B I D A D D E N D U M 0 3

ORANGE ULSTER BOCES (OUB Project # RFB-OUB-035009-24)

ARDEN HILL MAIN BLDG. – NORTH WING ALTERATIONS

**ARDEN HILL - MAIN BUILDING ALTERATIONS TO NORTH
WING**
ORANGE-ULSTER BOCES
BID ADDENDUM #3

Sheet Title
**REVISED ROOF PLAN
(DRAWING A251)**

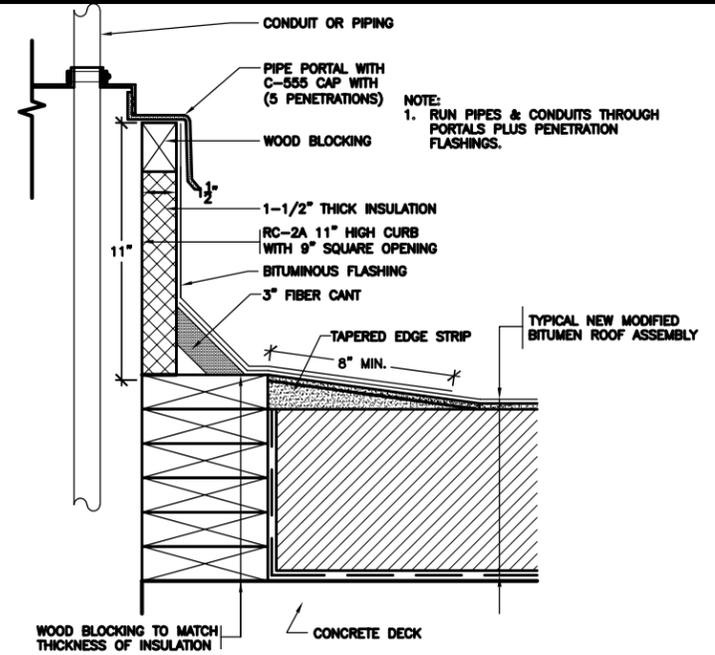
- 4.4 DRAWINGS A251 ROOF PLAN and A252 ROOF DETAILS – See attached ASK1a and ASK1b with revisions to the roof plan and additional roof details.
- 4.5 DRAWING A301 BUILDING ELEVATIONS – ADD the following note:
Exterior Building Washing/Cleaning and Brick Repointing Notes:

7.22 New roof top mechanical equipment is shown on the attached Sketch ASK1a for reference by the GC. GC shall coordinate with MEP trades for final sizes and locations of rooftop equipment.

39 PORTAL CURB
 SCALE: 0 1" 2" 4" 8"

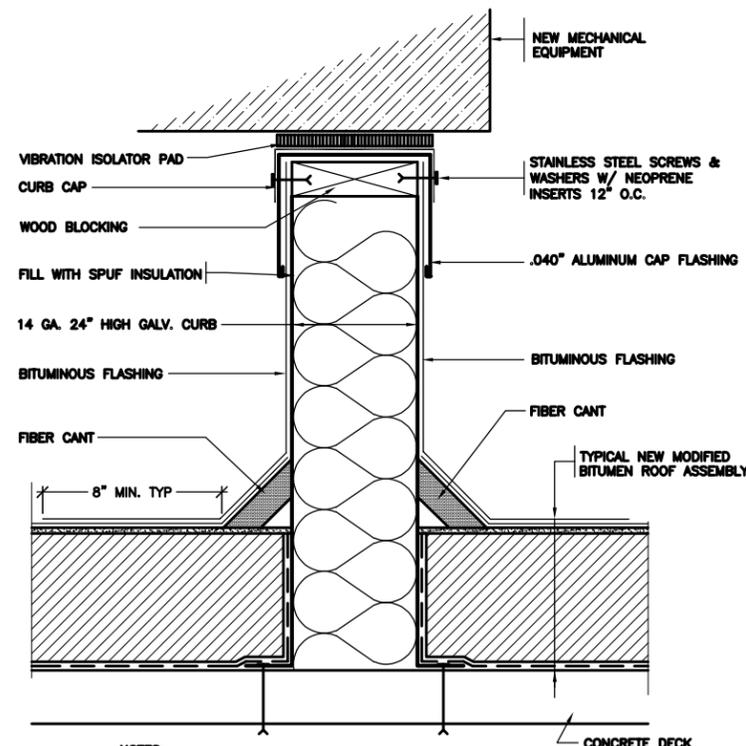
Attached Sketch ASK1b shows how to configure the Portals Plus Curb Flashings, Equipment Curb Rail Flashings, Duct Curb Flashings and Duct Waterproofing.

- a. The GC / Roofing Contractor shall supply and install Portals Plus penetration curbs for the electrical, control, supply and return lines. The Mechanical and Electrical Contractors shall install the conduits and lines through the Portals Plus curbs and rubber nipples.
- b. Duct supports shall be provided and installed by the Mechanical Contractor to support the ducts 24 inches above the finished roof surface. The GC shall supply and install the walkway pads and pavers.
- c. The GC shall supply and install the exterior duct insulation, EPDM waterproofing and white acrylic coating.

41 REVISED EQUIPMENT CURB
 SCALE: 0 1" 2" 4" 8"

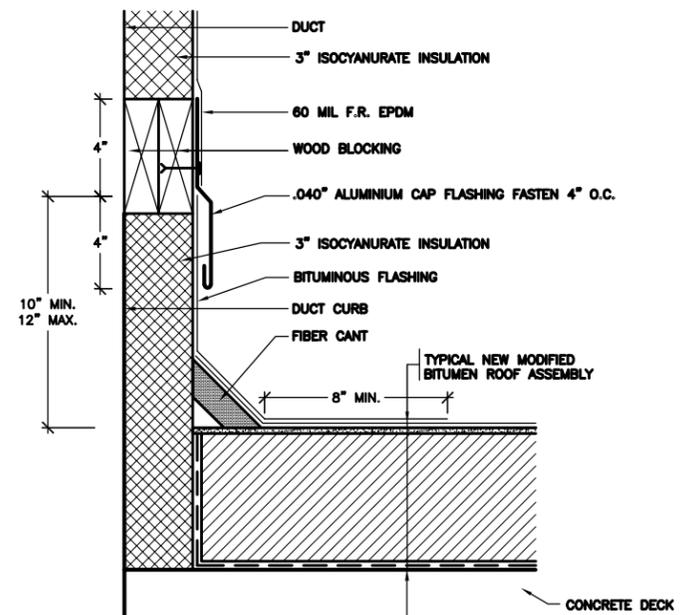
NOTES:
 1. NEW 24" HIGH CURBS FOR EQUIPMENT BY MECHANICAL CONTRACTOR.

43 DUCT WATERPROOFING (REVISED DETAIL: 7/A831)
 NOT TO SCALE

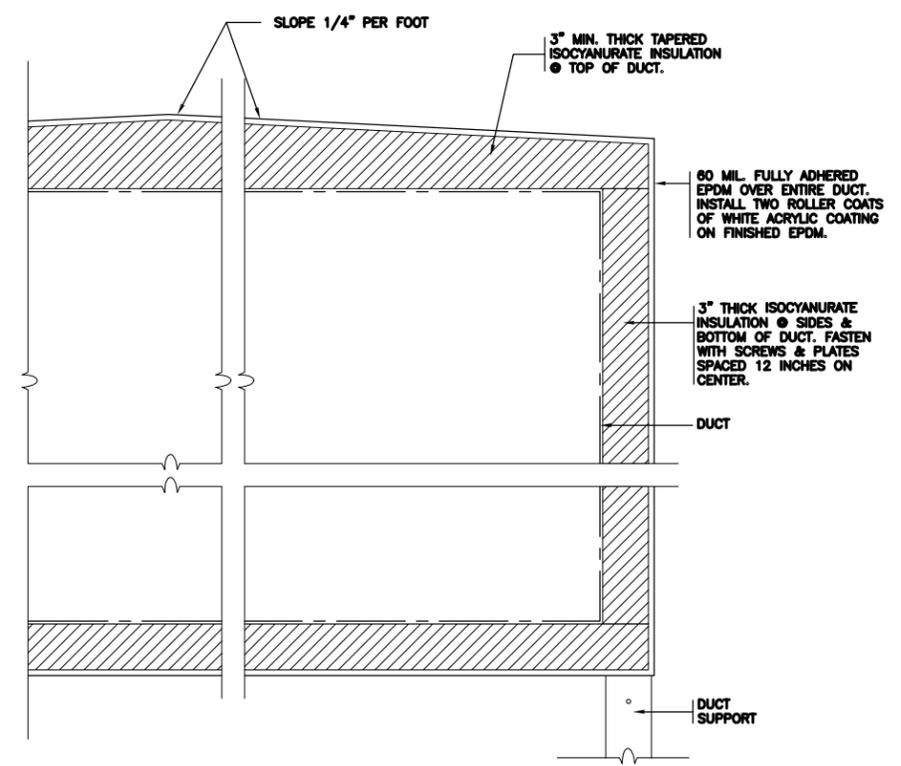
- 4.6 DRAWING 7/A831 ROOF PLAN – REVISE Detail 7. See attached ASK1b with detail 43 showing the revised duct waterproofing detail.

NOTES:
 1. COVER FASTENER HOLES AND SEAMS IN THE DUCT WITH PEEL AND STICK MEMBRANE. INSTALL NEW 3" THICK ISOCYANURATE INSULATION ON THE SIDES AND BOTTOM OF THE DUCTS, AND TAPERED INSULATION SLOPING 1/4" PER FOOT, MINIMUM 3" THICK ON TOP OF THE DUCTS. COVER THE INSULATION WITH 60 MIL FULLY ADHERED EPDM.
